# STRATHFIELD LOCAL PLANNING PANEL MEETING AGENDA

**Thursday 6 October 2022**

TO: Strathfield Local Planning Panel Meeting - 6 October 2022  
 REPORT: SLPP – Report No. 28  
 SUBJECT: DA2017.114.3- 9-13 BERESFORD ROAD STRATHFIELD  
 LOT 45 SP 83492  
 DA NO. DA2017.114.3

<b>Property:</b>	9-13 Beresford Road STRATHFIELD Lot 45 SP 83492 DA2017.114.3
<b>Proposal:</b>	Section 4.55(1A) Modification Application for internal alterations to change configuration of rooms in an approved boarding house.
<b>Applicant:</b>	C Jordan
<b>Owner:</b>	R Khoury
<b>Date of lodgement:</b>	11 April 2022
<b>Notification period:</b>	26 April 2022 to 17 May 2022
<b>Submissions received:</b>	Nil
<b>Assessment officer:</b>	P Santos
<b>Estimated cost of works:</b>	\$20,000.00
<b>Zoning:</b>	R3-Medium Density Residential - SLEP 2012
<b>Heritage:</b>	Yes – “Wairuna” Victorian Italiante style house (I96 – local heritage item)
<b>Flood affected:</b>	No
<b>Is a Clause 4.6 Variation Proposed:</b>	N/A (19% variation – S69(1)(a)(i) of Chapter 3 Diverse Housing of SEPP (Housing) 2021
<b>Local Planning Panel Criteria</b>	Contravenes a development standard by 19%
<b>RECOMMENDATION OF OFFICER:</b>	<b>REFUSAL</b>

Figure 1. Extract of the ground floor plan in the subject modification application.

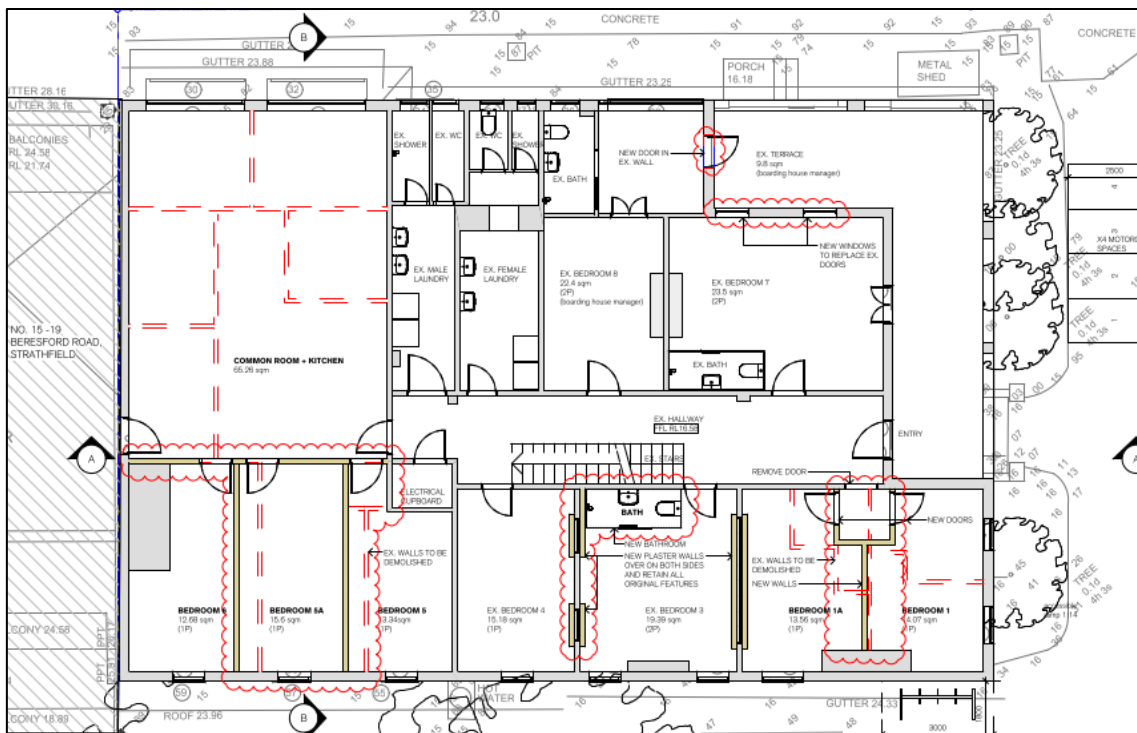
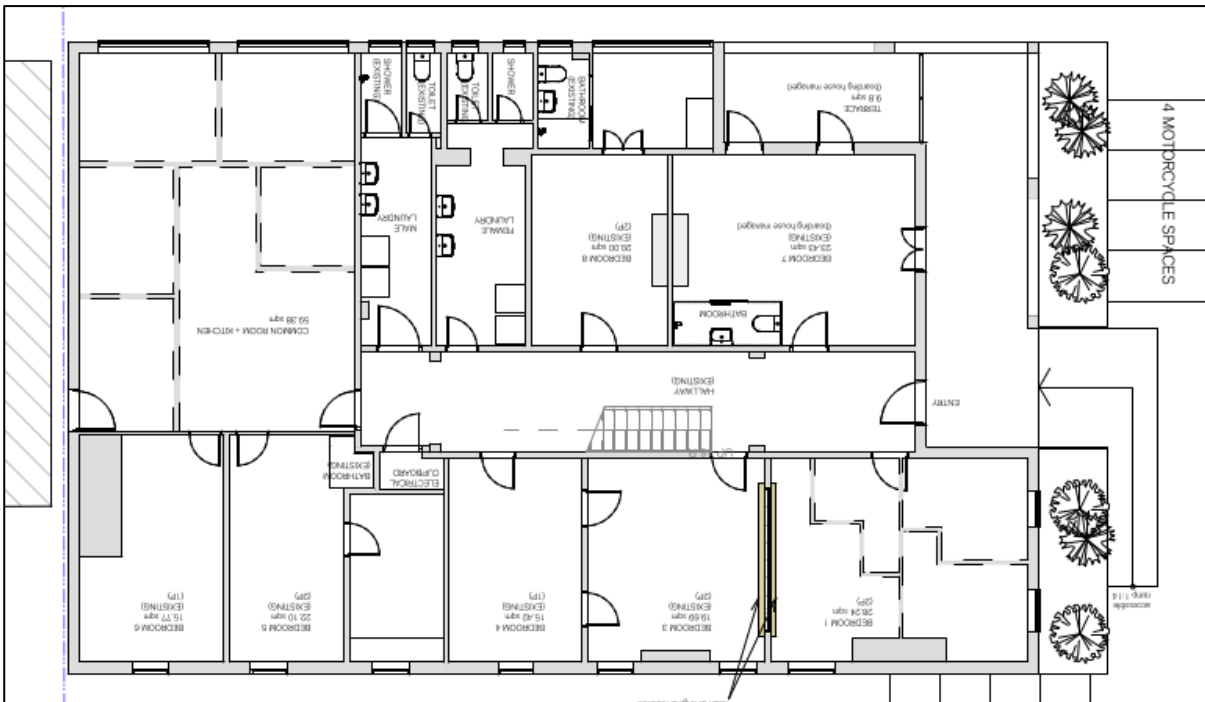
The proposal will result to an increase in the number of rooms from 19 to 21 – 12 single occupancy, 8 double rooms and a manager’s room. No additional parking is proposed with the application.

Figure 3. Extract of the first floor plan in the subject modification application.

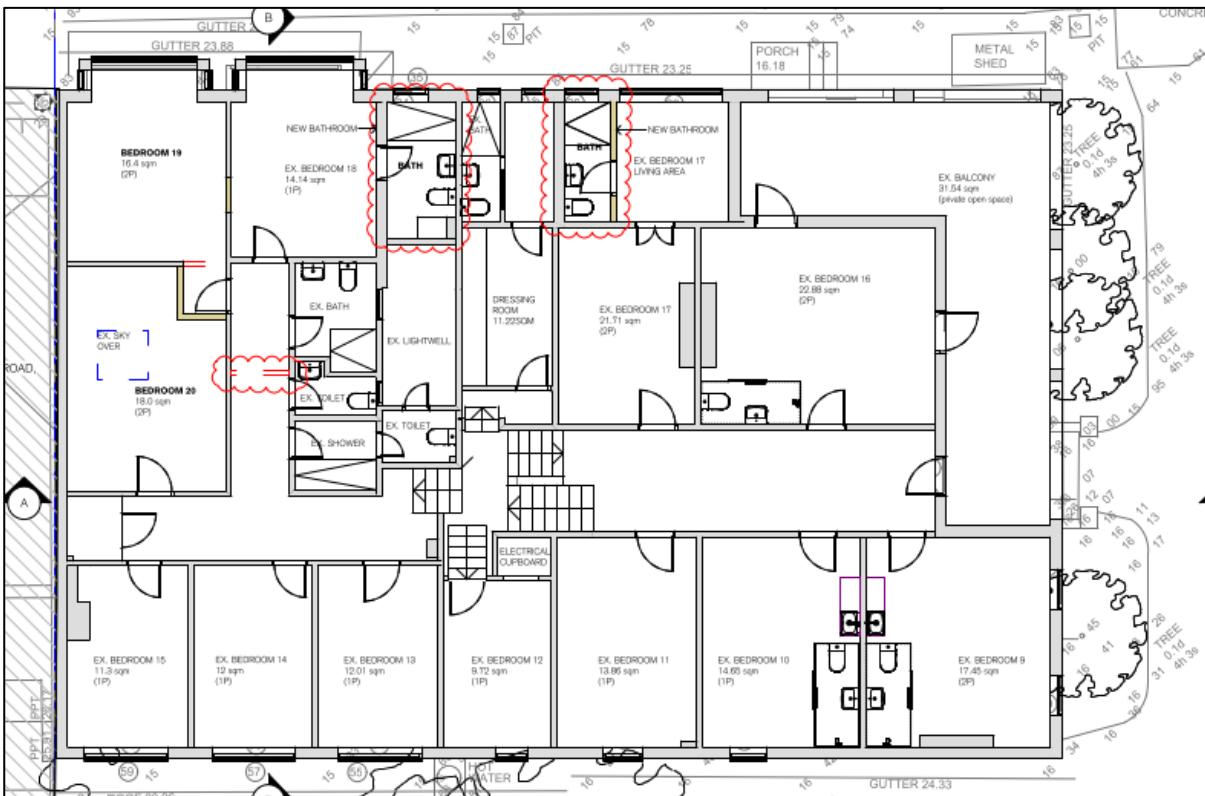
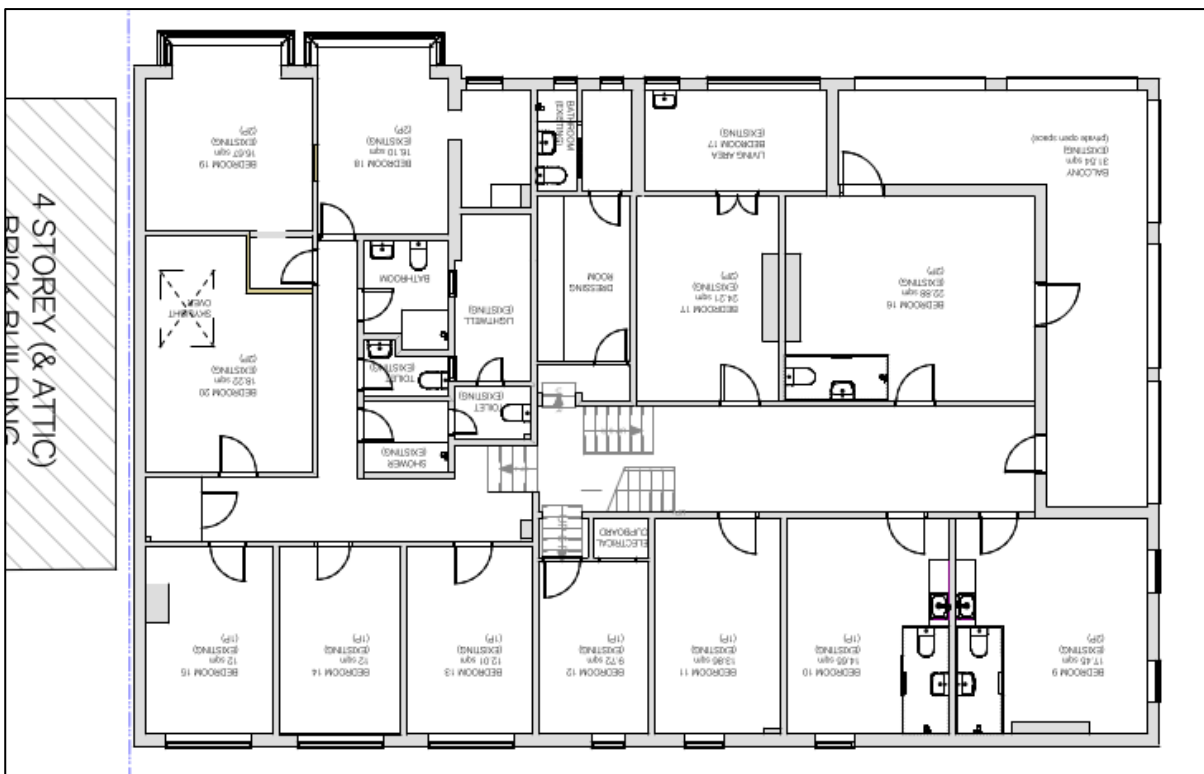
The modification application documentation includes plans that indicate that the subject room highlighted in Figure 5 is still under in floor area and that a new room has a reduced floor area that is less than the minimum required – Room 15 with 11.3m<sup>2</sup>. It is noted that in the new SEPP (Housing) 2021, this room sizes requirement is a standard and not a non-discretionary standard, unlike in the SEPP ARH.

**Figure 24 – Proposed development interface with existing development at 76-78 Marlborough Road**

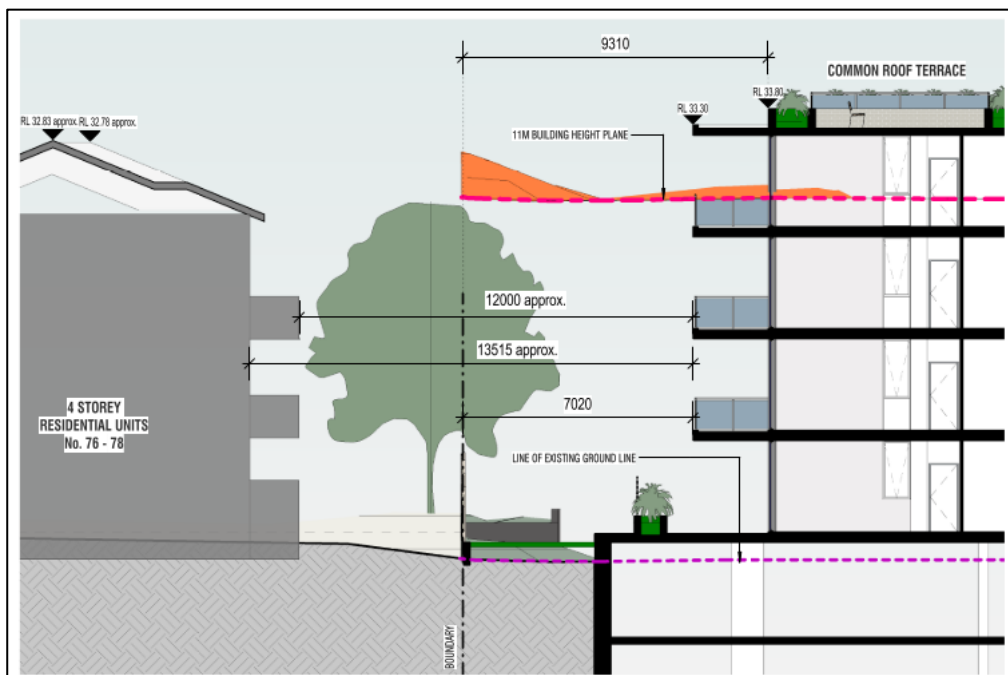
Further, the fourth floor results in direct overlooking from units along the northern and parts of the western elevation into existing developments to the north and west. A moderate setback for the fourth floor would contribute to addressing this. However, this would require re-design of units across the fourth floor and cannot be conditioned.
